# ARLINGTON AVENUE BRIDGES REPLACEMENT

## Survey Response Summary

((March 1, 2021 – April 1, 2021))

# Question 3:

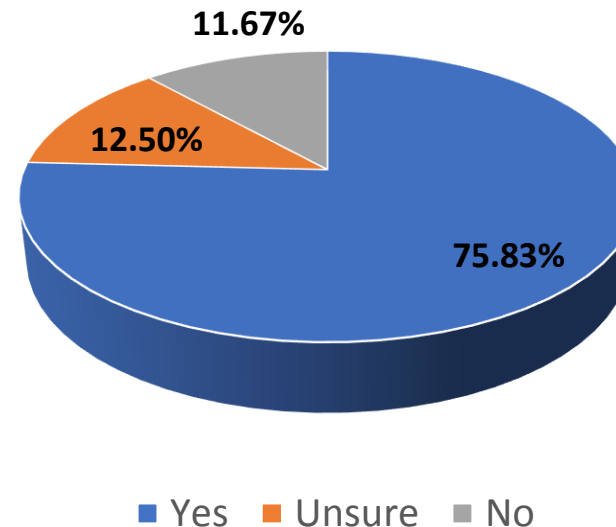
## Question 3 Comment Themes

Support of using the tied arch concept (an eliminated alternative) which more aesthetically pleasing like the Virginia Street Bridge.

Concerned about the ability of the designs to accommodate debris and flow during flood events.

# Question 5:

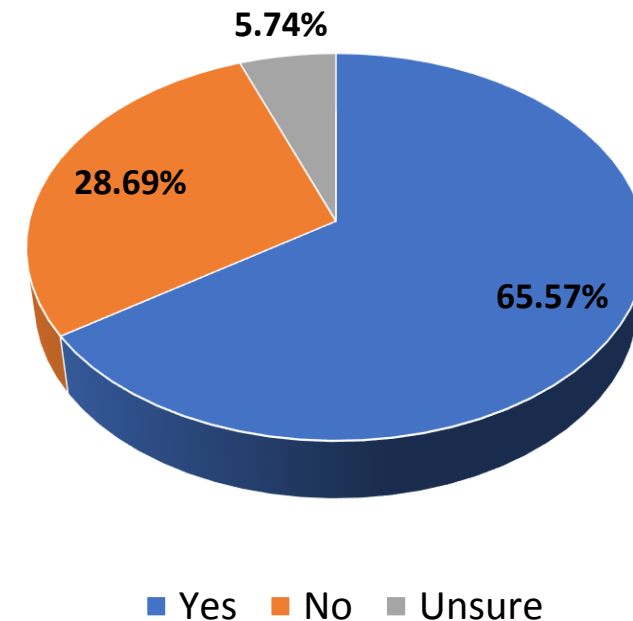
## Question 5 Comment Themes

Concerns regarding the ability of the single pier design to accommodate debris and flow during flood events. Commenters see the pier as a future liability.

Commentors seem to favor the clear span for flooding concerns and aesthetics.

Concern about creating a place vagrants to frequently utilize.

Commenters are focused on providing pleasant pedestrian experiences, specifically, providing increased headroom.

## Question 6:

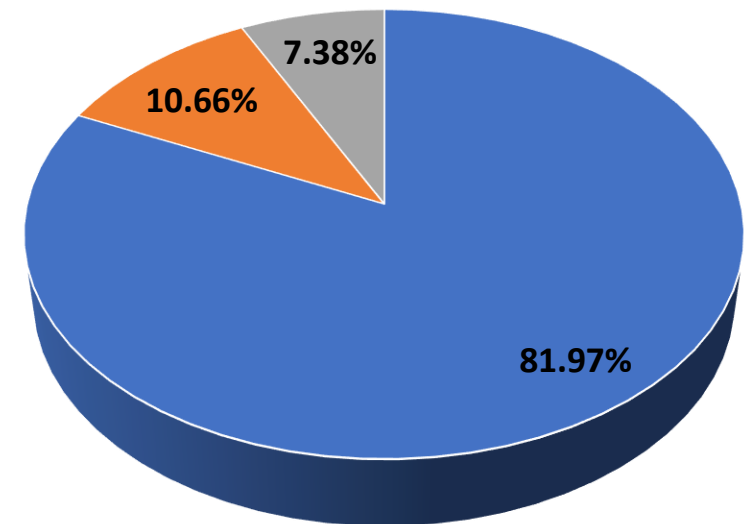
### Question 6 Comment Themes

Design should be the same for all bridges.

### Question 7 Comment Themes

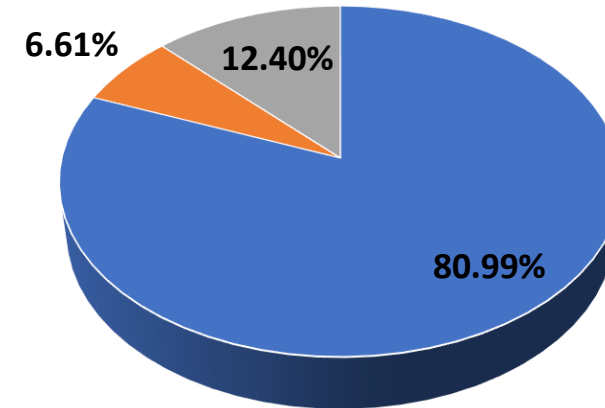
More lighting for safety.

Concerned about lighting impacts on wildlife and the river ecology.

## Question 9:

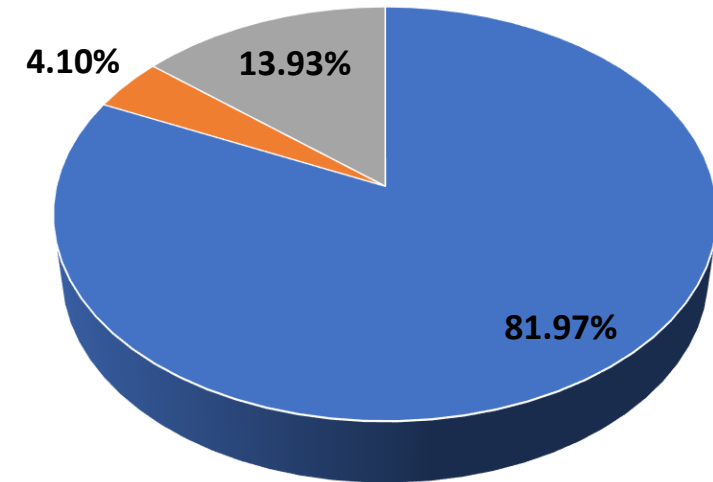
### Question 9 Comment Themes

Of those who commented, about half want the access freedom the single railing would provide, especially during local events.

The opposing half of commentators would prefer double railing to provide increased safety to pedestrians.
